10 Mb/s Single Twisted Pair Ethernet 10BASE-T1L PSD Mask Changes (Comment #192)

Steffen Graber
Pepperl+Fuchs

Suggested Changes to PSD Mask

New PSD Limit Equations

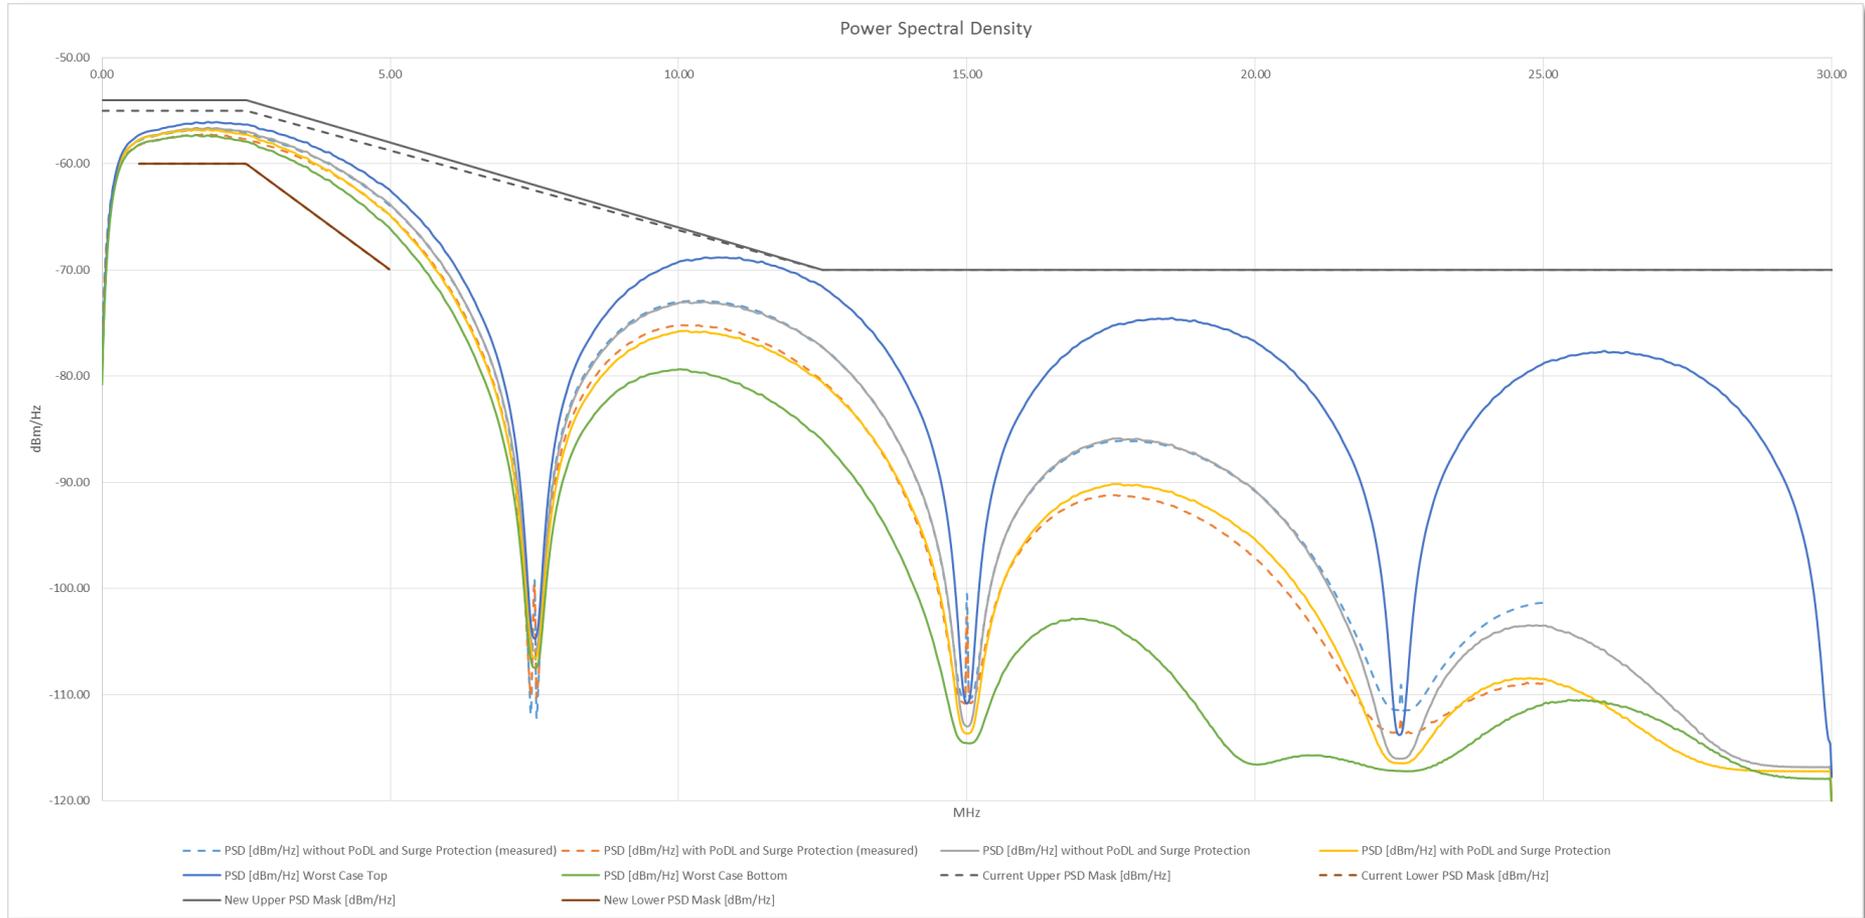
- Equations 146-6 to 146-9 specify the upper and lower PSD limits, Figure 146-19 shows the PSD limits graphically.
 - The **difference between upper and lower PSD limits is currently only 5 dB**, which is small compared to the PSD masks of other Ethernet standards.
 - The measured PSD of the FPGA based evaluation board, which has been trimmed to exactly output 2.4 V_{pp} is about 1 dB nearer at the upper limit than at the lower limit.
 - Therefore the suggestion is to **increase the upper PSD mask limit by 1 dB** in the frequency range between 0 and 2.5 MHz.
 - **Resulting is a difference between upper and lower PSD limits of 6 dB**, which is similar to other Ethernet standards.
 - **All other values are kept the same.**

- PSD mask limits for a transmit signal amplitude of $2.4 V_{pp}$:

$$\text{Upper PSD Limit } (f) = \begin{cases} -54 \frac{\text{dBm}}{\text{Hz}} & 0 \leq f \leq 2.5 \text{ MHz} \\ -54 - 1.6 \cdot (f - 2.5 \text{ MHz}) \frac{\text{dBm}}{\text{Hz}} & 2.5 \text{ MHz} < f < 12.5 \text{ MHz} \\ -70 \frac{\text{dBm}}{\text{Hz}} & 12.5 \text{ MHz} \leq f \leq 20 \text{ MHz} \end{cases}$$

$$\text{Lower PSD Limit } (f) = \begin{cases} -60 \frac{\text{dBm}}{\text{Hz}} & 0.625 \text{ MHz} \leq f \leq 2.5 \text{ MHz} \\ -60 - 4 \cdot (f - 2.5 \text{ MHz}) \frac{\text{dBm}}{\text{Hz}} & 2.5 \text{ MHz} < f \leq 5 \text{ MHz} \end{cases}$$

New PSD Mask (2.4 Vpp Amplitude)

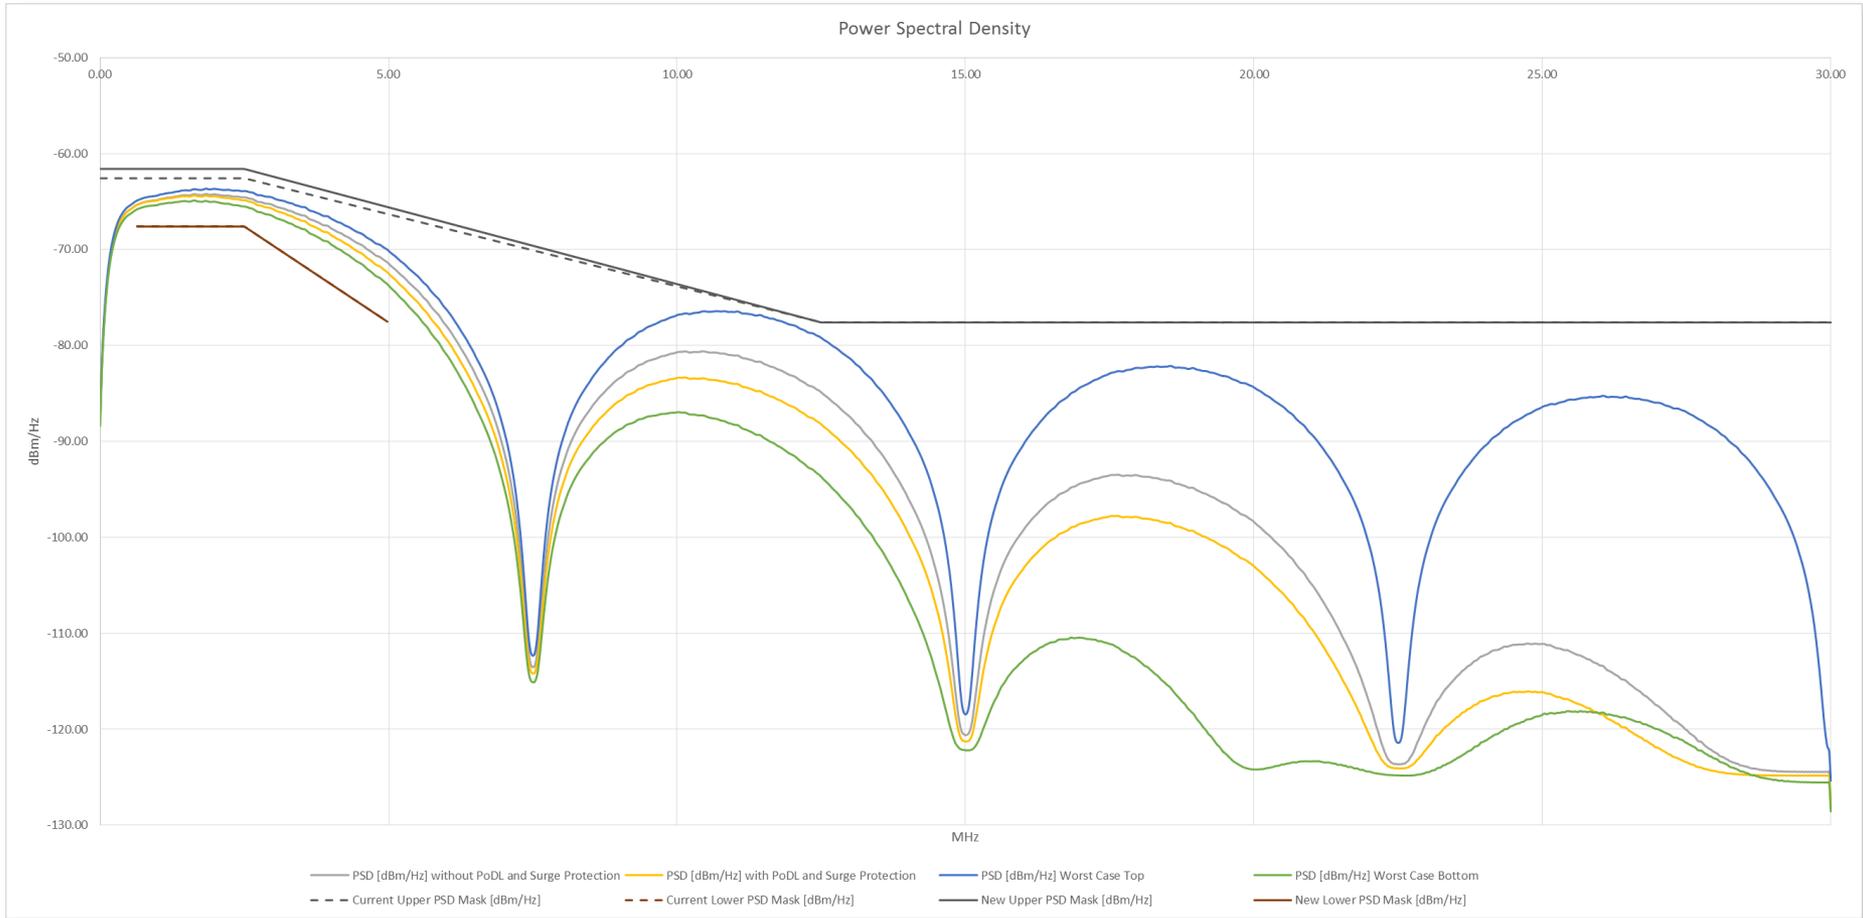
- The dashed limit curves show the current PSD mask limits, the solid limit curves show the new suggested PSD mask limits.
